DESIGN/DEVELOPMENT REVIEW COMMISSION
DESIGN REVIEW DISTRICT
HISTORIC/CONSENT AGENDA
EVALUATION SHEET
Case #5

CASE NUMBER: DDRC-2024-0030

ADDRESS: 2601 Cherry Street

NATURE OF REQUEST: Request for Certificate of Design Approval for construction of eight townhouses.

REAR ELEVATION
1/4" = 1'-0"

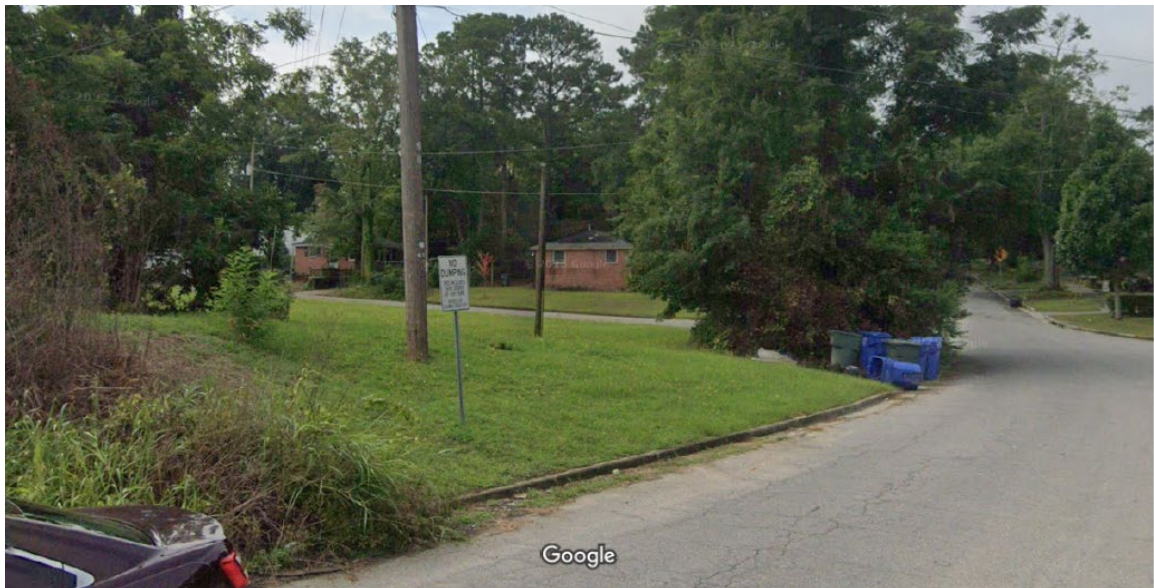
Staff are requesting two additional windows on the second story rear façade. The second story will be visible from the surrounding streets and needs to maintain an appropriate rhythm of openings. The proposed windows will be towards the center of the façade, between the windows that are currently in the design. These can be smaller square or diamond shaped as found in the district. This has been illustrated by staff at the end of this evaluation. Adding these windows will ensure the design is in keeping with the guidelines.

The rendering on the right shows the final window placement as submitted, with the suggested addition of two additional windows. Staff presented both a square and a diamond shape. Either would be acceptable, but they must be the same on all units. This would improve the rhythm of openings on this elevation. The first floor will not be visible from the public right of way due to the fencing around the property.

- All windows will have a casing of 1x4 boards.
- Two windows will be added to the rear second floor center façade. Details to be worked out with staff.
- All material choices for outstanding items be deferred to staff to work out with the applicant;
- All other details deferred to staff.
